HIGHLAND CITY DEVELOPMENT ADMINISTRATION BOARD AGENDA

2. ACTION: Final Plat Approval for Ridgeview Plat N

DATE: May 22, 2025
TO: Development Administration Board
FROM: Rob Patterson, City Attorney / Planning & Zoning Administrator
SUBJECT: **Final Plat Approval:** Ridgeview Plat N
TYPE: **LAND USE (ADMINISTRATIVE)**

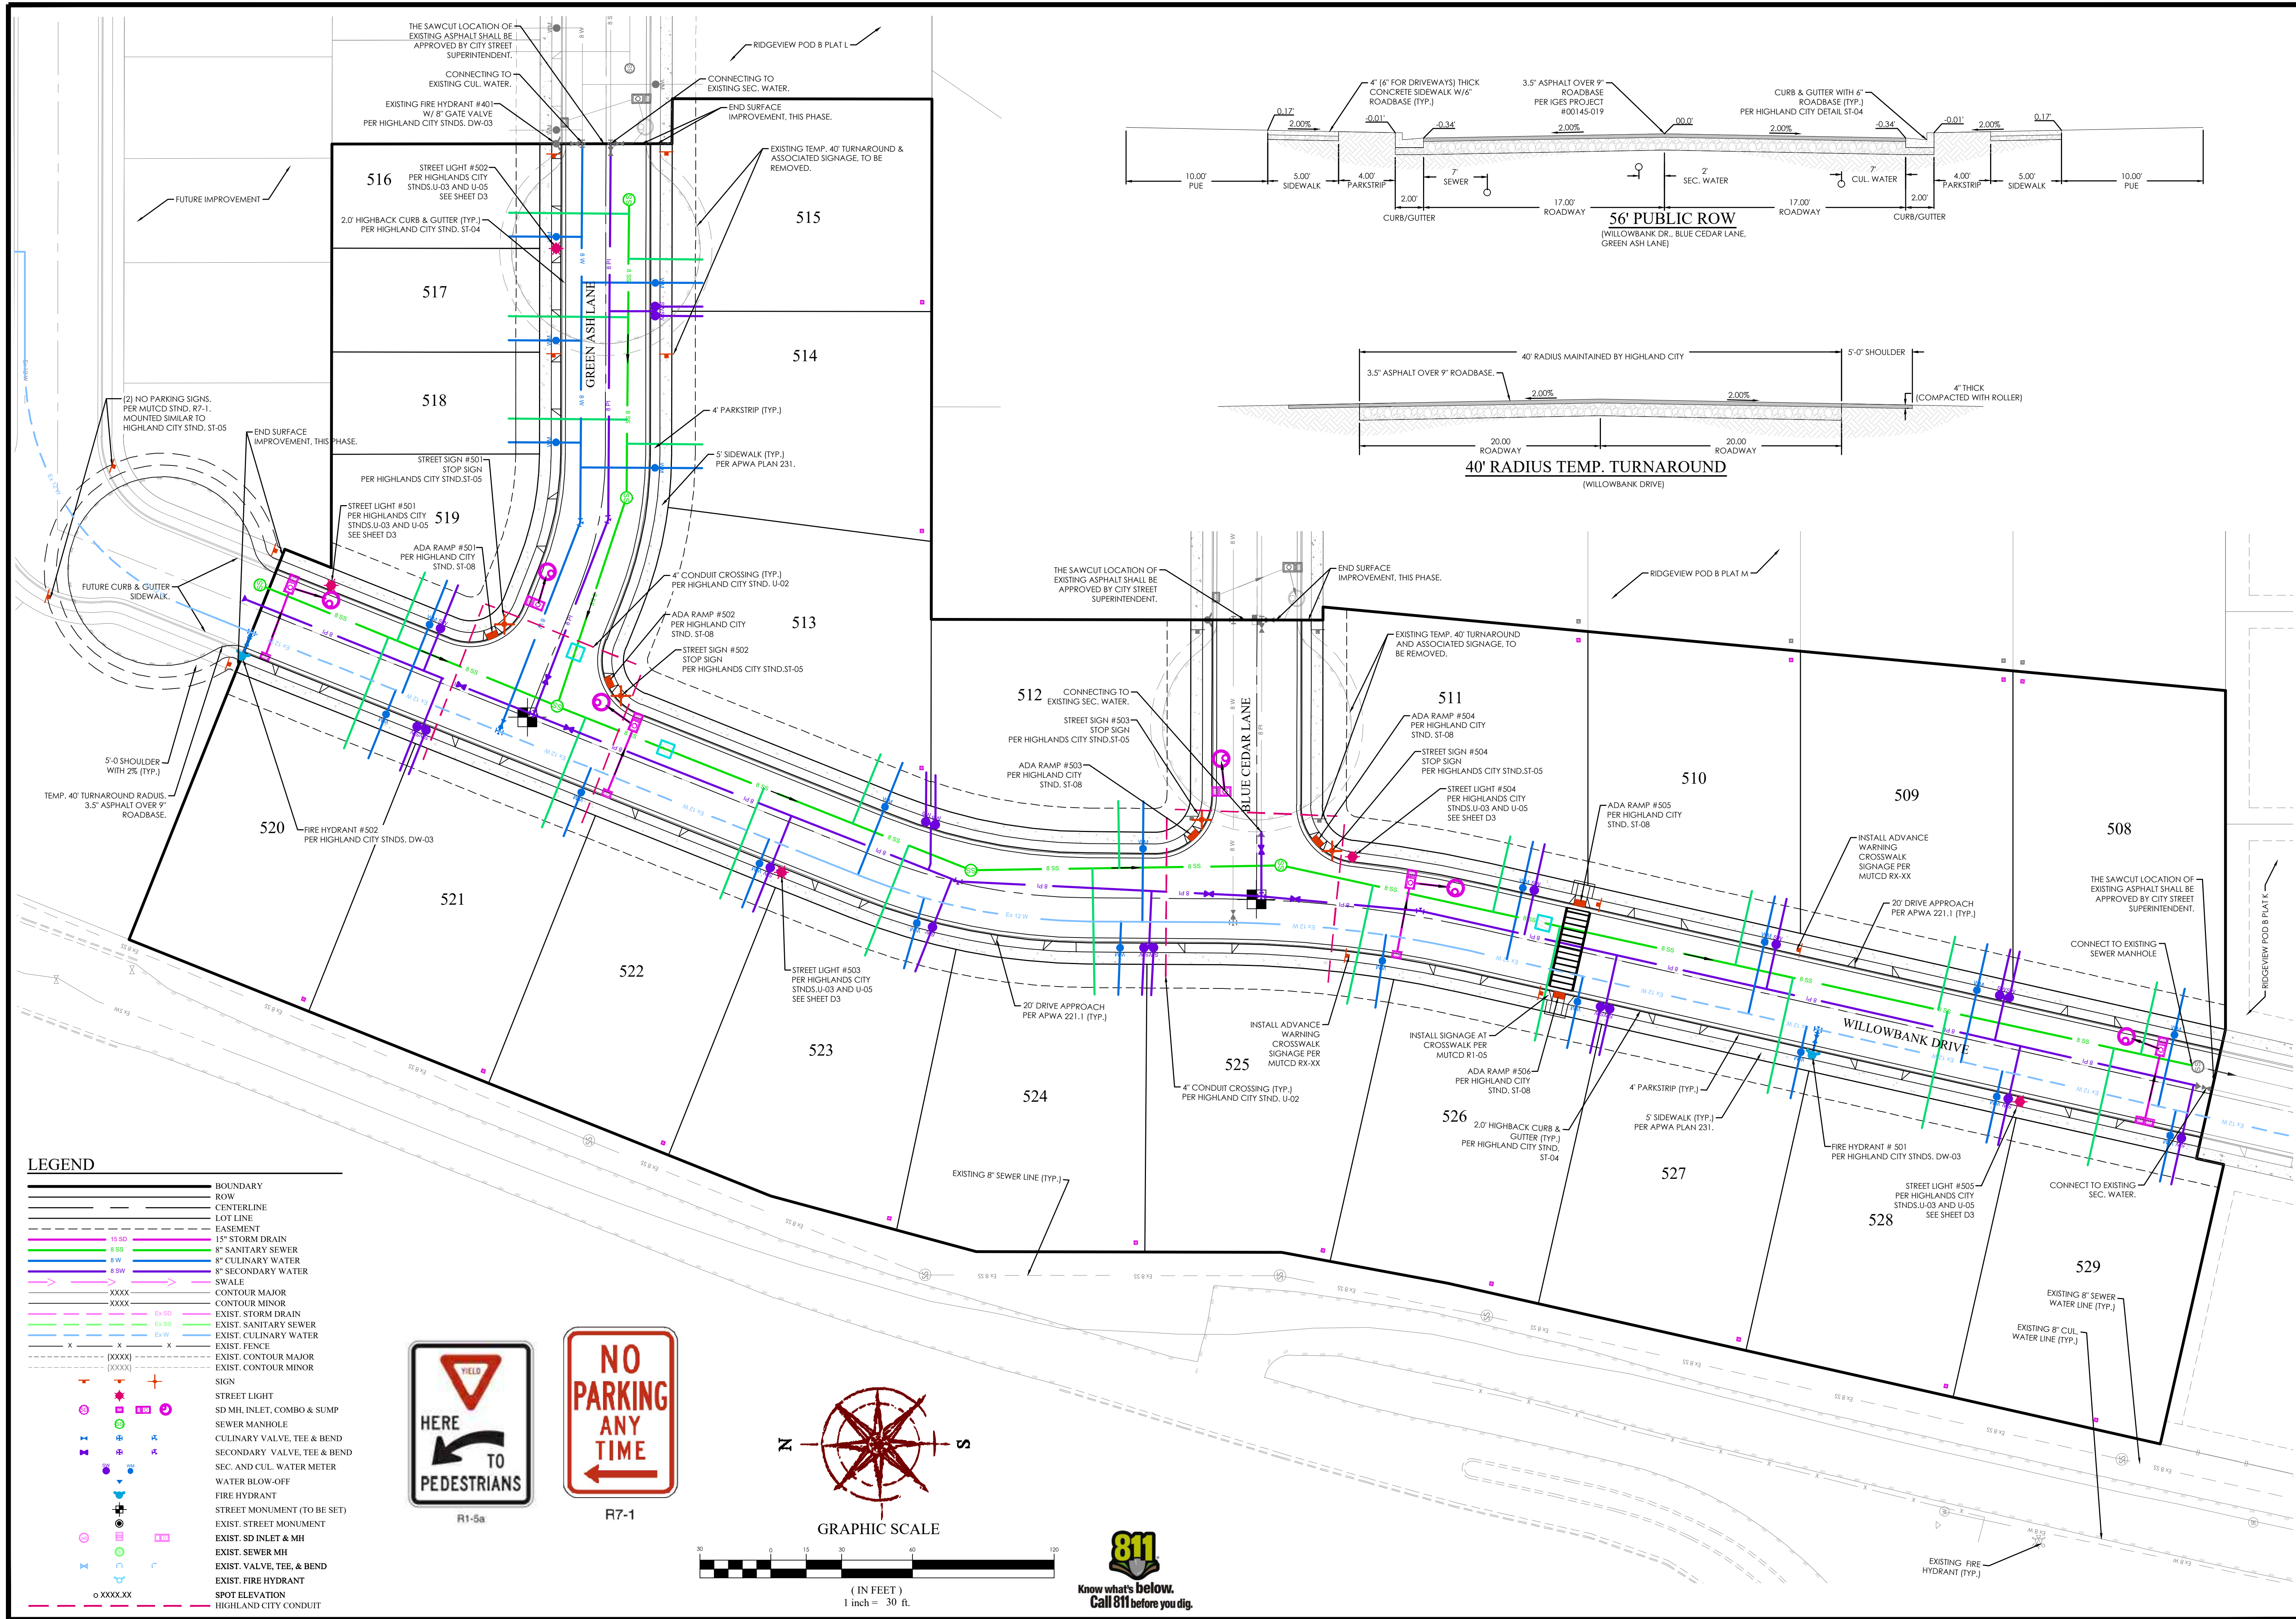
1. Plat must receive final review from JUB and Utah County for conformance and recordability.
2. Lot addresses to be added after approval.
3. Add Storm Drain notes for private sumps that were included in Plats L and M.
4. Blue Cedar Lane is misspelled as “Line” on Plat – correct prior to printing.

SITE PLAN	
Scale: 1"=30'	Drawn: CRP
Date: 04/16/25	Job #: 24-0388
Sheet:	C3

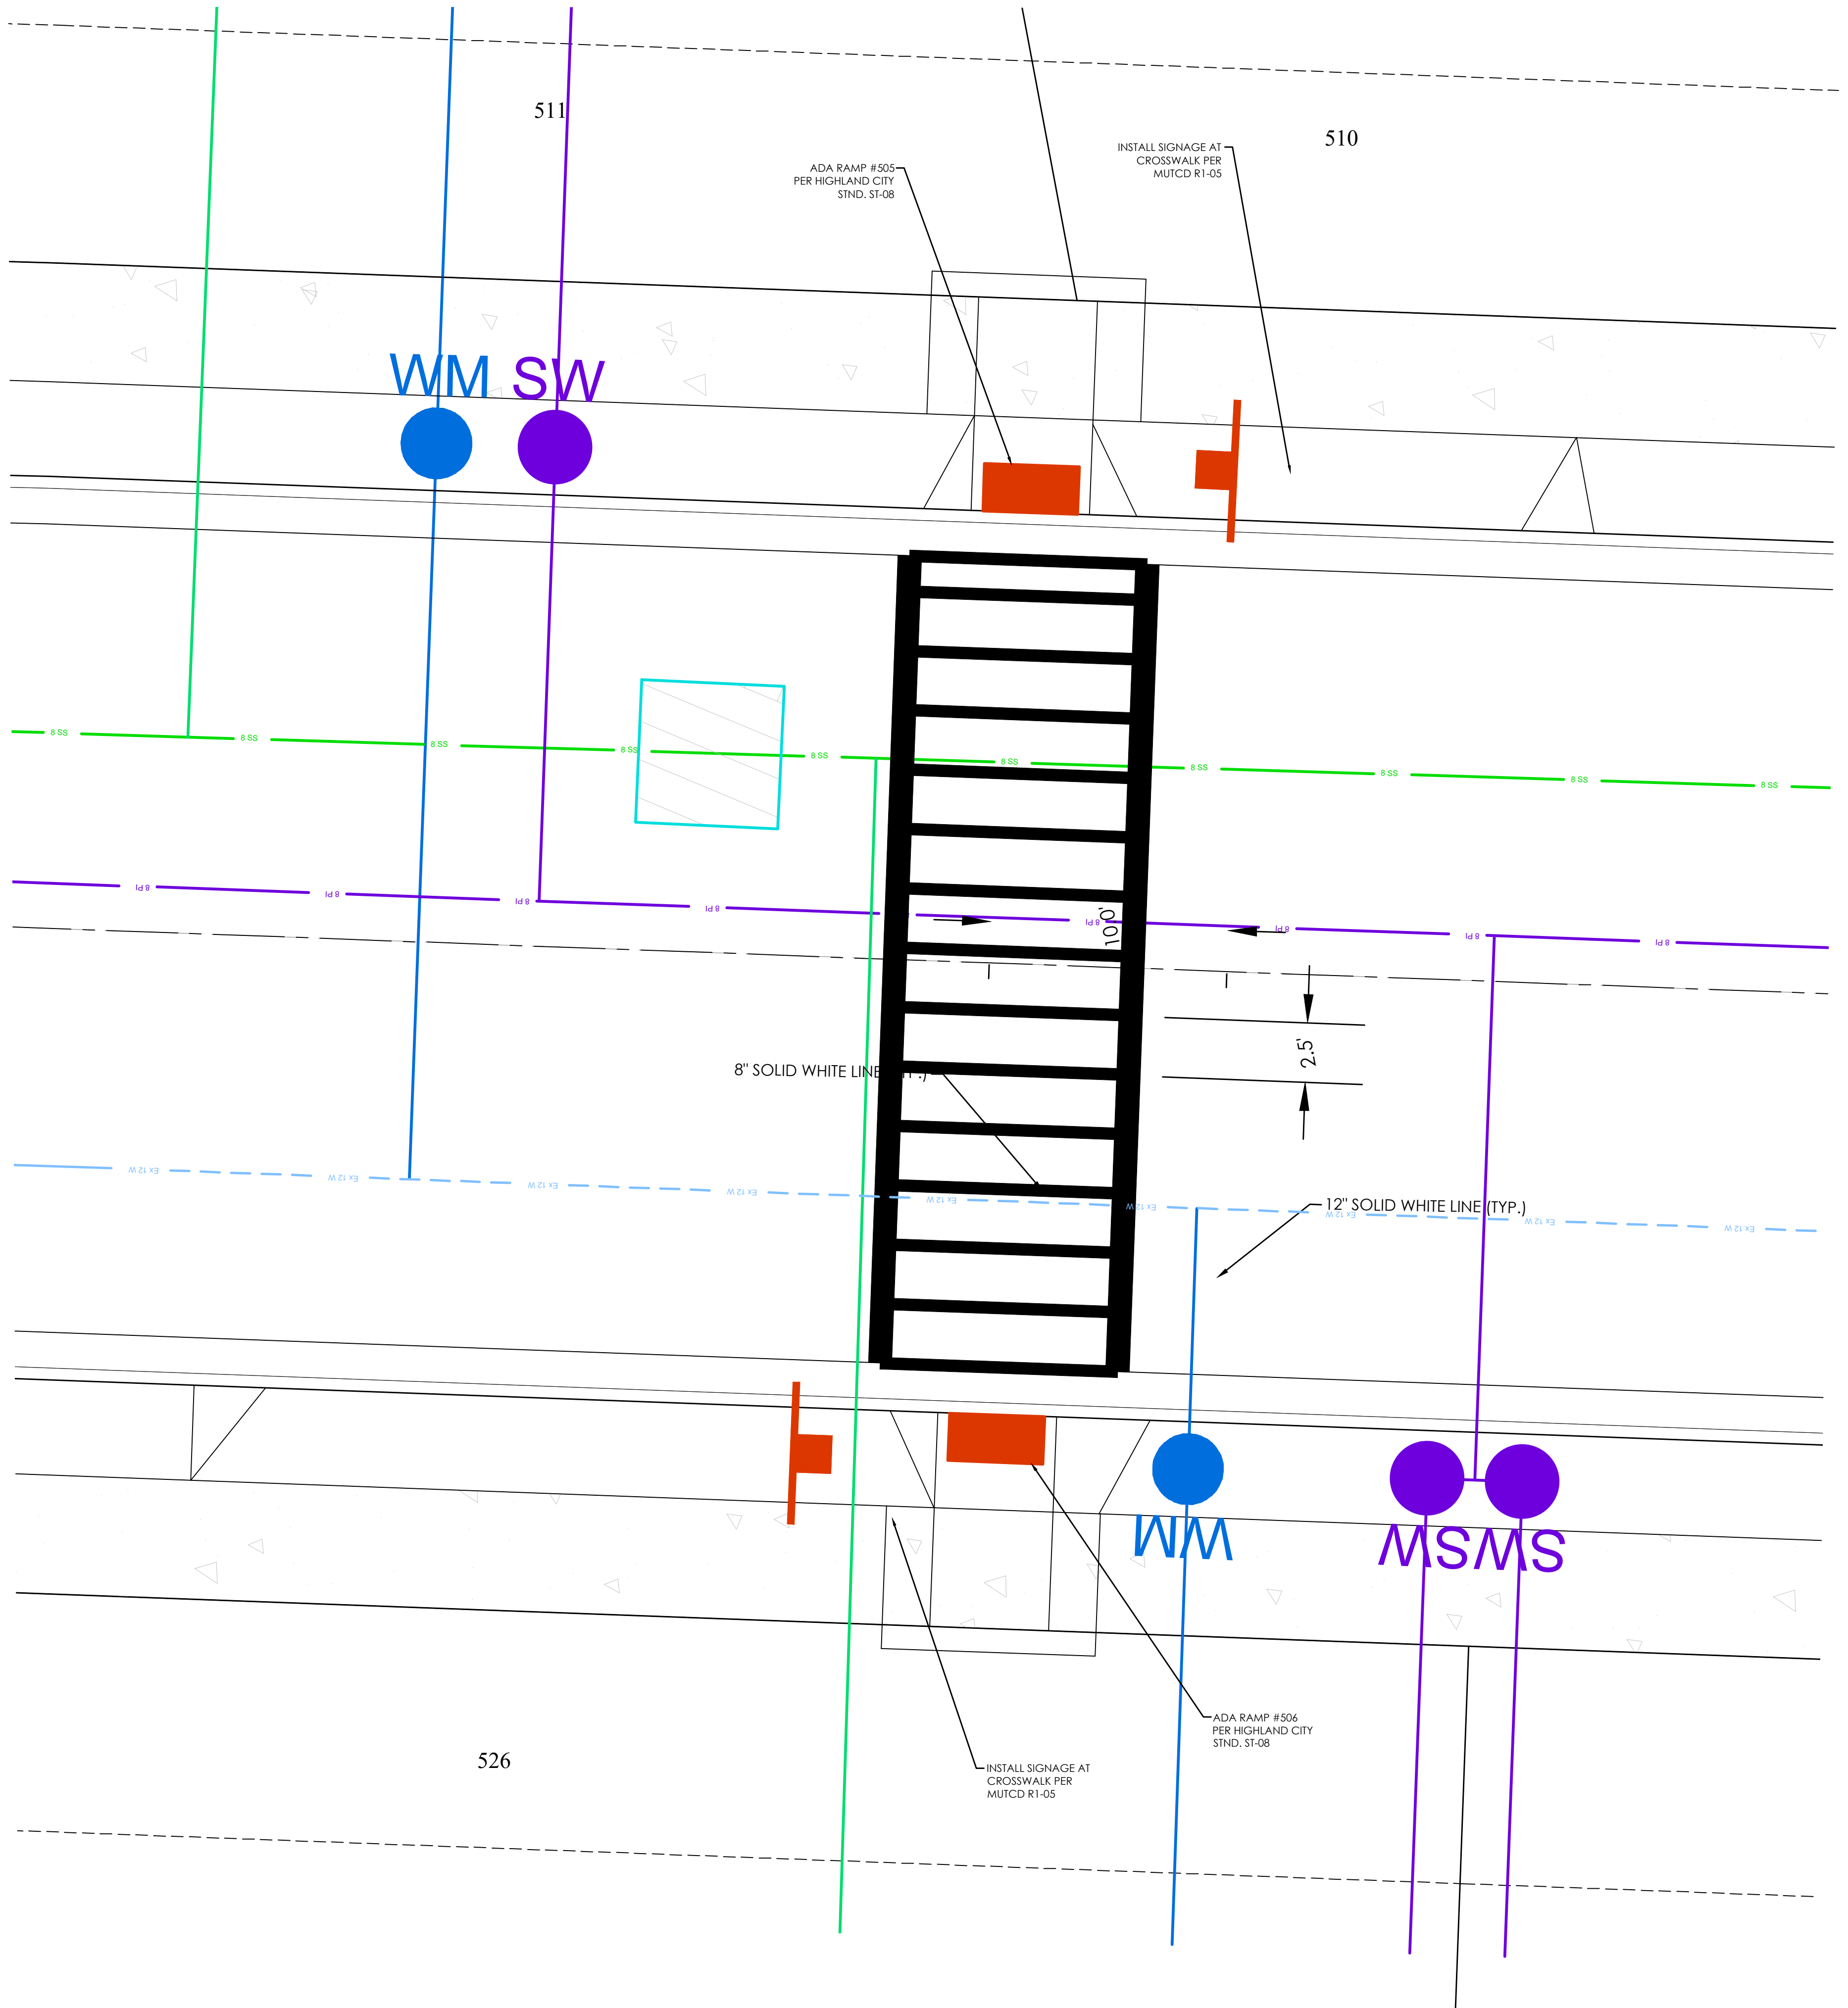
5. The PUD/Development Agreement requires that fencing along Knight Avenue be constructed, to match previously installed. Please provide a note on the site plan stating that ‘Future Fencing along the back of the lots to be installed consistent with the existing fencing and Ridgeview PUD requirements.’
